Decision Date: March 26, 2020

Re: AA-2019-6353-PMLA
6304 N. Allott Avenue
Van Nuys-North Sherman Oaks Community Plan
Zone : R1-1
D.M. : 177-B-157
C.D. : 2 -Krekorian
CEQA : ENV-2019-6354-CE
Legal Description: Portion of Lot 13; Tract: 13062

SITE ADDRESS: 6304 N ALLOTT AVE. NORTH HOLLYWOOD
PROPOSED PROJECT:
PARCEL MAP FROM LOT TO 3 SINGLE FAMILY PARCELS.

PRELIMINARY PARCEL MAP LA NO.
SITE ADDRESS: 6304 N ALLOTT AVE. NORTH HOLLYWOOD

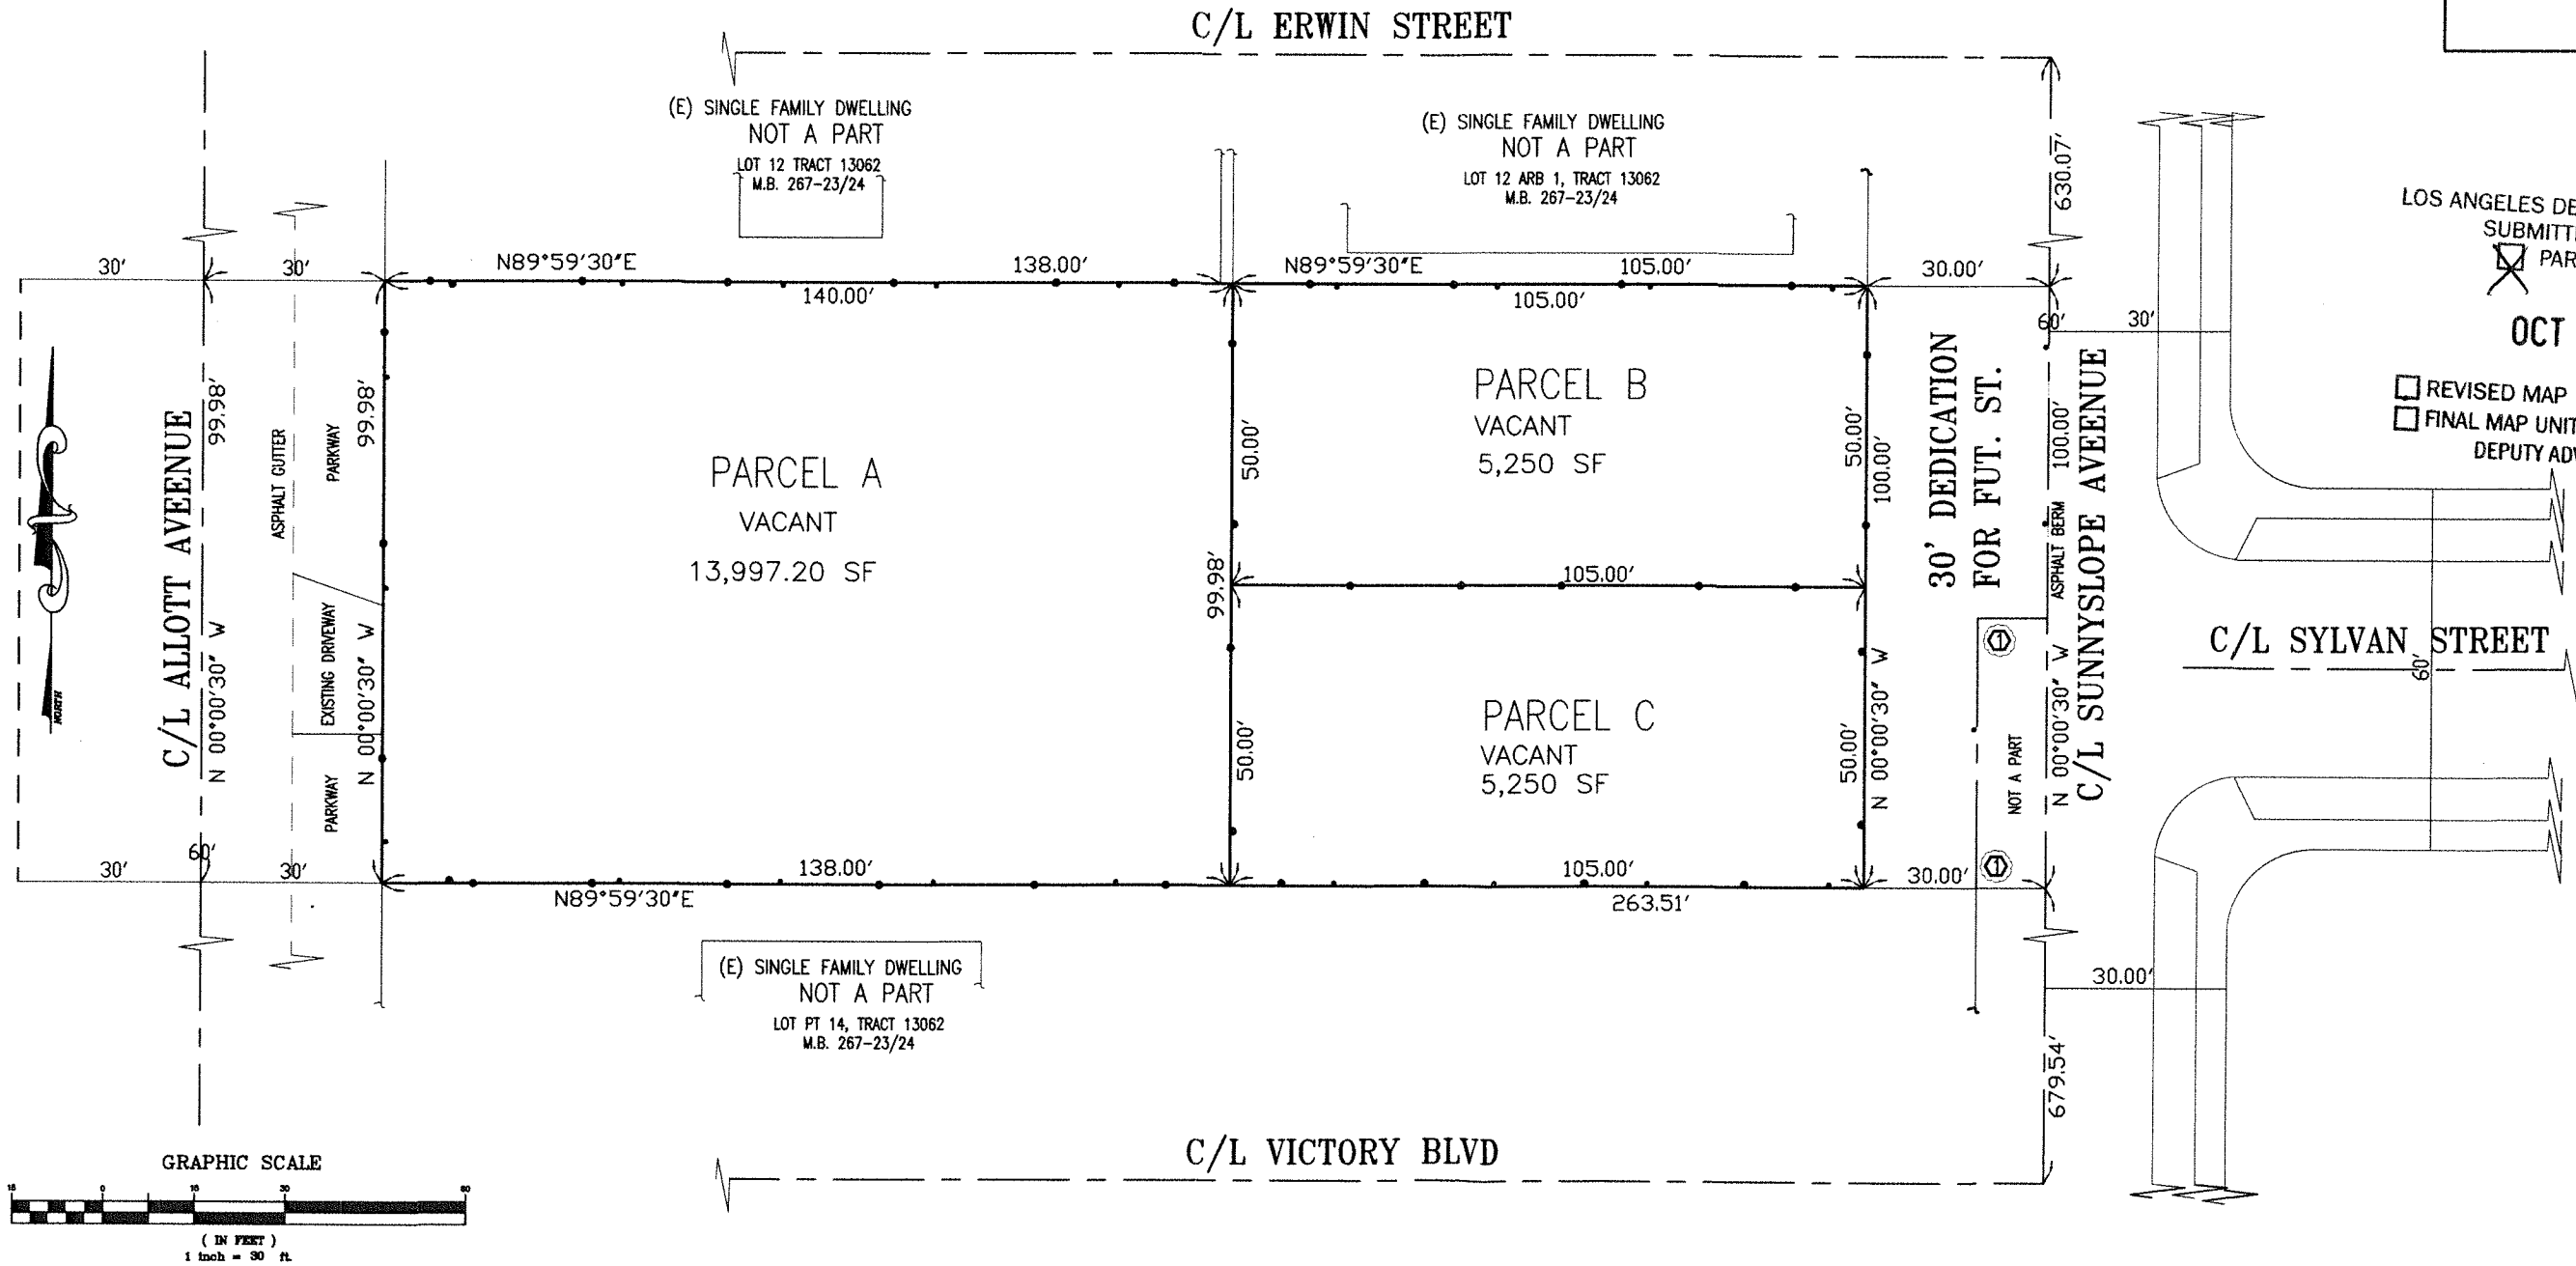
1. That the subdivider attempt to obtain the variable wide strip of land, shown at the preliminary parcel map as “not a part” for public street purposes from the owner of said parcel. In the event the off-site dedication for Sunnyslope Avenue cannot be obtained, suitable evidence shall be submitted to the Advisory Agency and City Engineer indicating that an offer at fair market value was made and that the owner of the property has refused the offer or failed to respond to a certified letter within 30-day.

2. In the event the off-site public street dedication over the “Not a Part” area cannot be obtained; a revised map shall be submitted showing both parcels having minimum required roadway/driveway access in the portion of Sunnyslope Avenue northerly of the “Not a Part” area satisfactory to the City Engineer.

3. That a 30-foot and variable wide strip of land be dedicated along Sunnyslope Avenue adjoining the subdivision over the subdivider’s ownership area to complete a 30-foot wide half right-of-way and 60-foot total right-of-way dedication in accordance with **Local Street** Standards of the LA Mobility Plan.

- (1) Construct new street light: One (1) on Allott Avenue.

- (i) That the following improvements are either constructed prior to recordation of the final map or that the construction is suitably guaranteed:
 - a) Improve Allott Avenue adjoining the subdivision by the construction of the following:

- (1) An integral concrete curb and gutter, and a 5-foot wide concrete sidewalk and landscaping of the parkway.
 - (2) Suitable surfacing to join the existing pavements and to complete an 18-foot wide half roadway.

- (3) Any necessary removal and reconstruction of existing improvements.
 - (4) The necessary transitions to join the existing improvements.
 - b) Improve Sunnyslope Avenue being dedicated and adjoining the subdivision by the construction of the following:

- (1) An integral concrete curb and gutter, and a 5-foot wide concrete sidewalk and landscaping of the remainder sidewalk area.

- (2) Suitable surfacing to join the existing pavements and to complete a 36-foot wide total roadway.
 - (3) Any necessary removal and reconstruction of existing improvements.
 - (4) The necessary transitions to join the existing improvements.
 - (5) Construct proper drainage at the new terminus of Sunnyslope Avenue.
 - (6) In the event that off-site public street dedication over the "Not a Part" area cannot be obtained, construct an asphalt berm across the roadway in said area satisfactory to the City Engineer.
- c) Construct mainline and house connection sewers to serve each parcel.
